# ADDENDUM #1

## KEARNEY PUBLIC SCHOOLS NEW KEARNEY HIGH SCHOOL - FOUNDATION PACKAGE KEARNEY, NEBRASKA 1355-F

Wilkins Hinrichs Stober Architects, L.L.C.  
2908 West 39<sup>th</sup> Street, Suite A  
Kearney, Nebraska 68845  
308-237-5787

Date Issued: September 12, 2014

Attachment No. S1.1-1  
to Addendum No. 1  
Dated: September 12, 2014

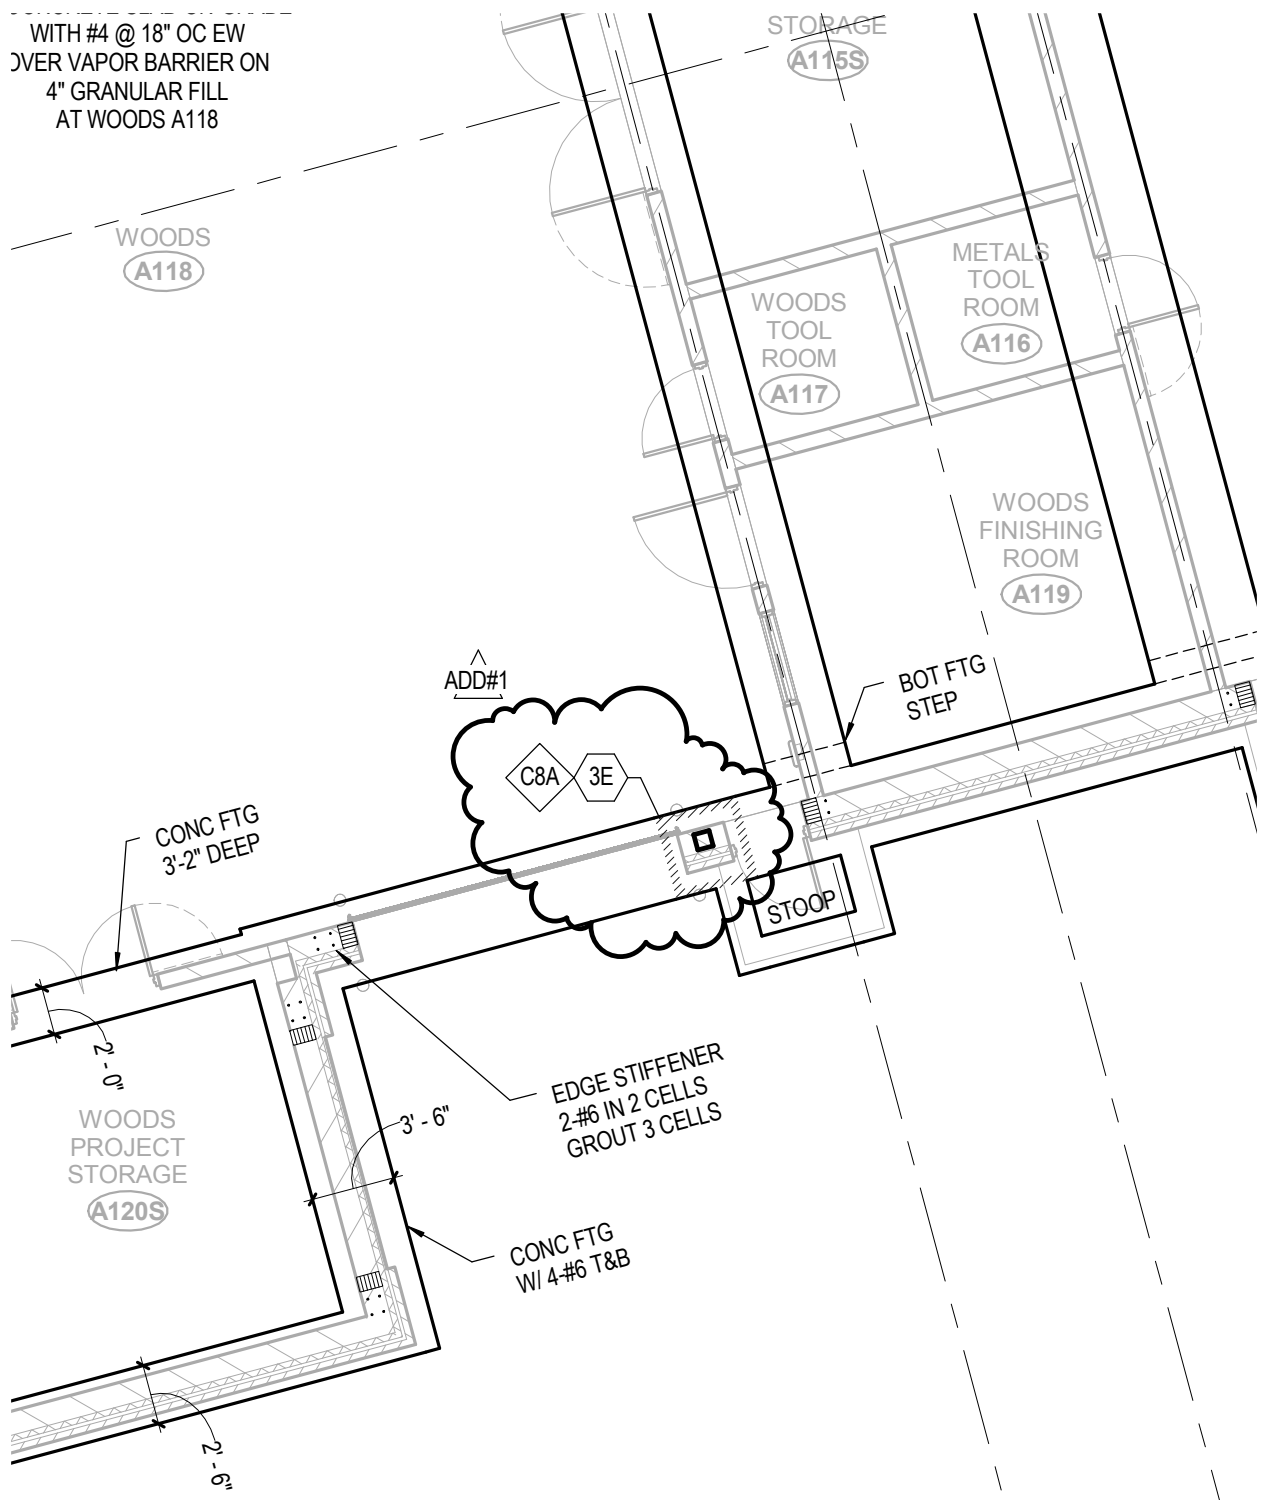
- Addendum #1 - #17 SHEET S1.1 – FOUNDATION PLAN – AREA A**
- c. Modify drawing as shown on Attachment S1.1-1 to Addendum No. 1, dated September 12, 2014. Drawing modified to show spread footing changes.

Attachment No. S1.1-2  
to Addendum No. 1  
Dated: September 12, 2014

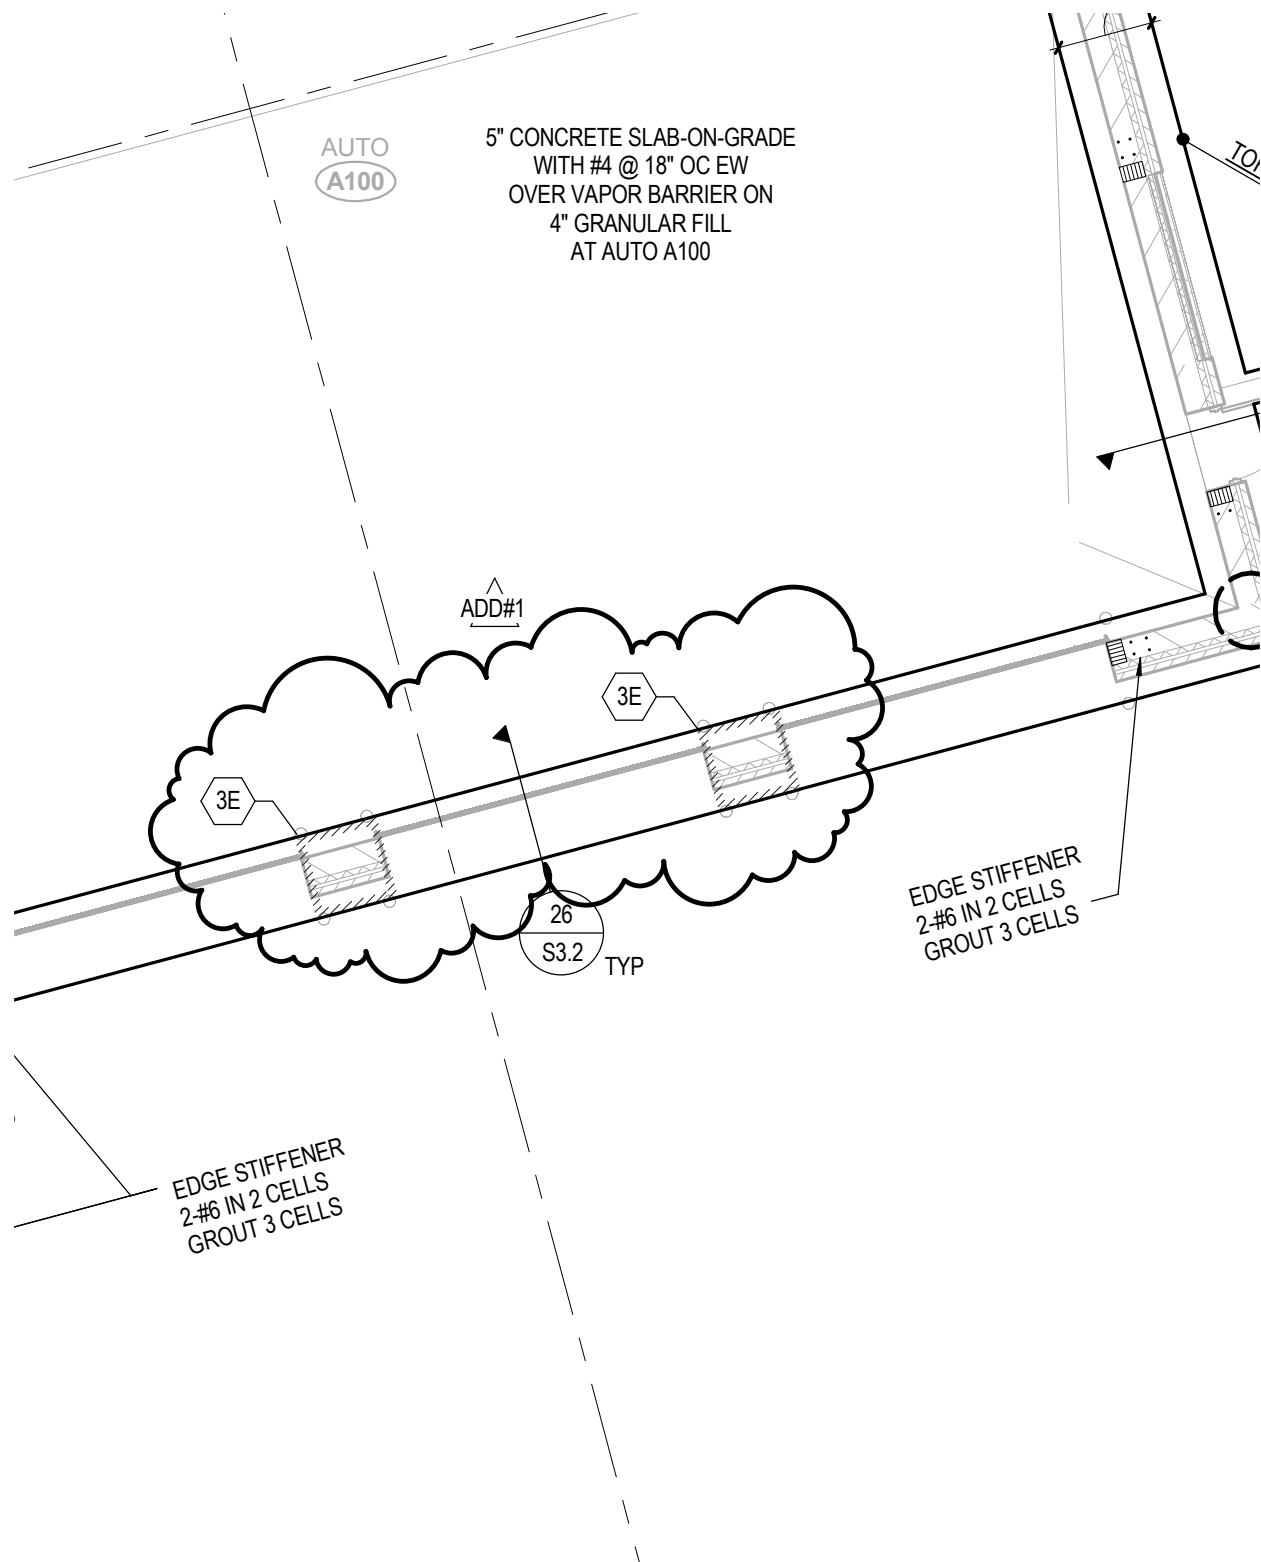
- d. Modify drawing as shown on Attachment S1.1-2 to Addendum No. 1, dated September 12, 2014. Drawing modified to show spread footing changes.
- Addendum #1 - #18 SHEET S1.2 – FOUNDATION PLAN – AREAS B & AA**

Attachment No. S1.2-1  
 to Addendum No. 1  
 Dated: September 12, 2014

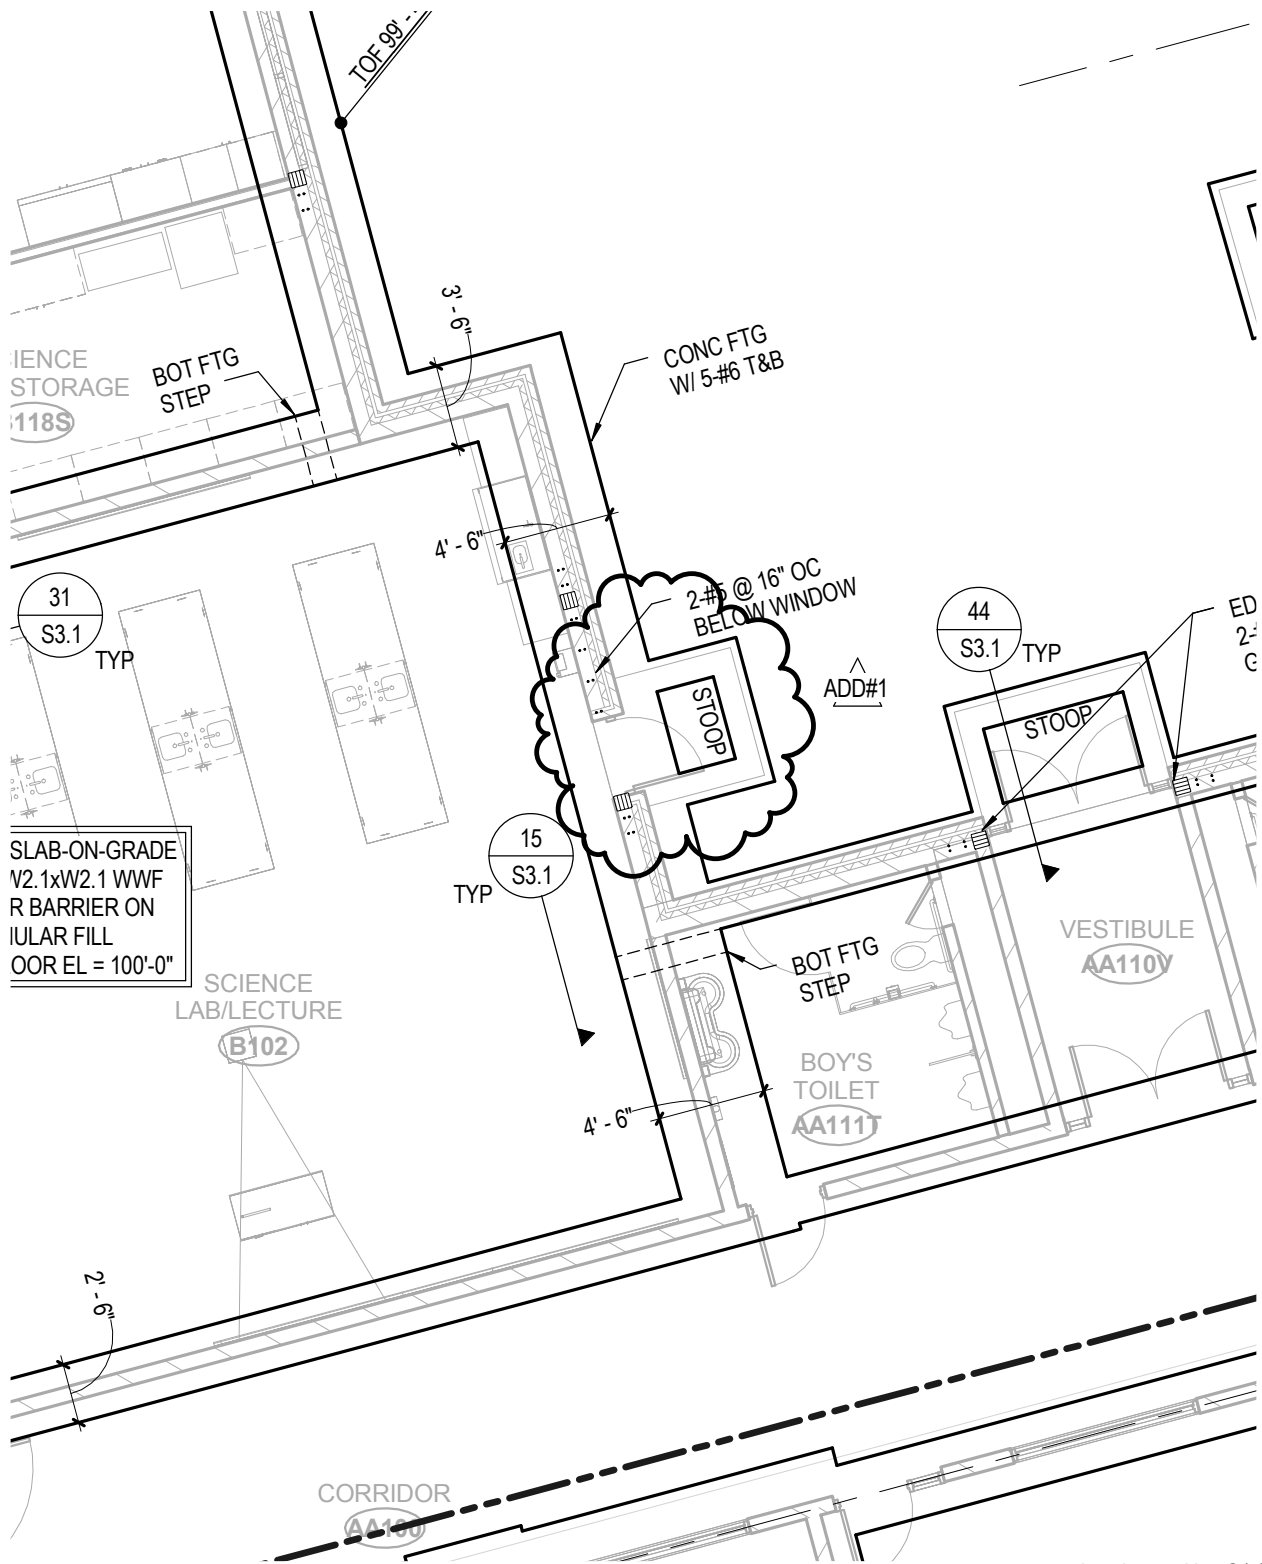
- a. Modify drawing as shown on Attachment S1.2-1 to Addendum No. 1, dated September 12, 2014. Drawing modified to add stoop.
  - b. Modify drawing as shown on Attachment S1.2-2 to Addendum No. 1, dated September 12, 2014. Drawing modified to adjust extent of stoop.

Attachment No. S1.3-1  
 to Addendum No. 1  
 Dated: September 12, 2014

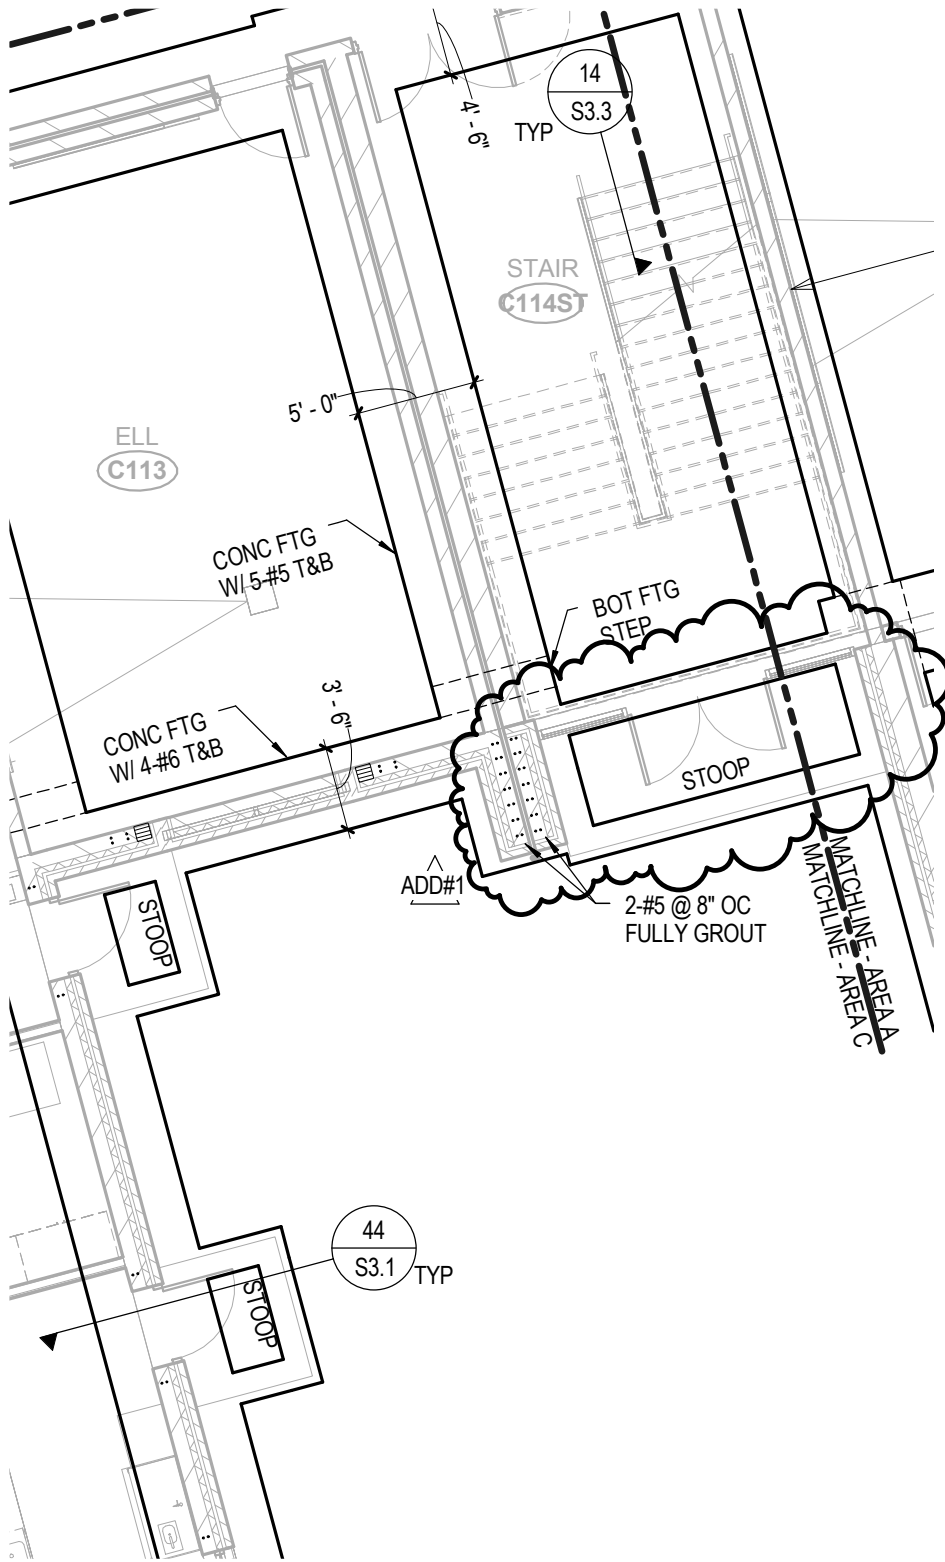
- Addendum #1 - #19 SHEET S1.3 – FOUNDATION PLAN – AREA C**
- a. Modify drawing as shown on Attachment S1.3-1 to Addendum No. 1, dated September 12, 2014. Drawing modified to adjust extent of stoop.

Attachment No. S1.3-2  
 to Addendum No. 1  
 Dated: September 12, 2014

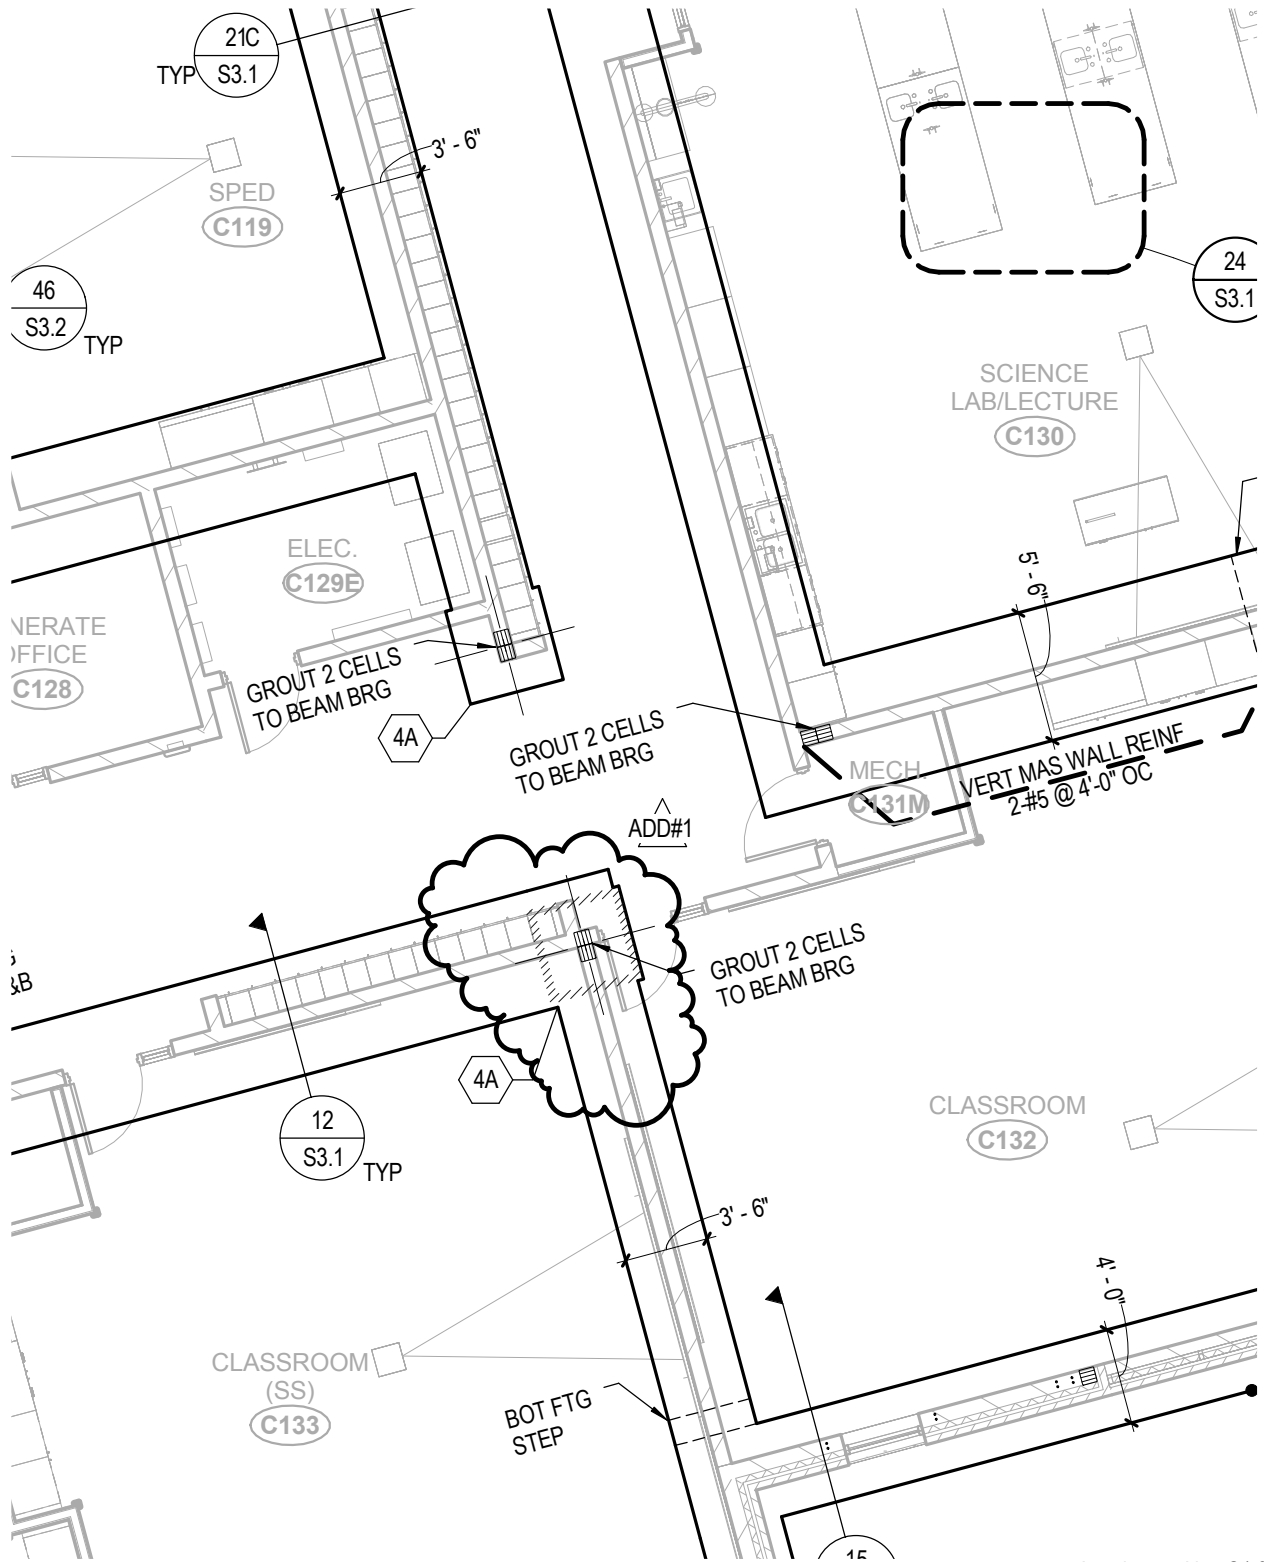
- b. Modify drawing as shown on Attachment S1.3-2 to Addendum No. 1, dated September 12, 2014. Drawing modified to add spread footing.
  - c. Modify drawing as shown on Attachment S1.3-3 to Addendum No. 1, dated September 12, 2014. Drawing modified to shift spread footing.
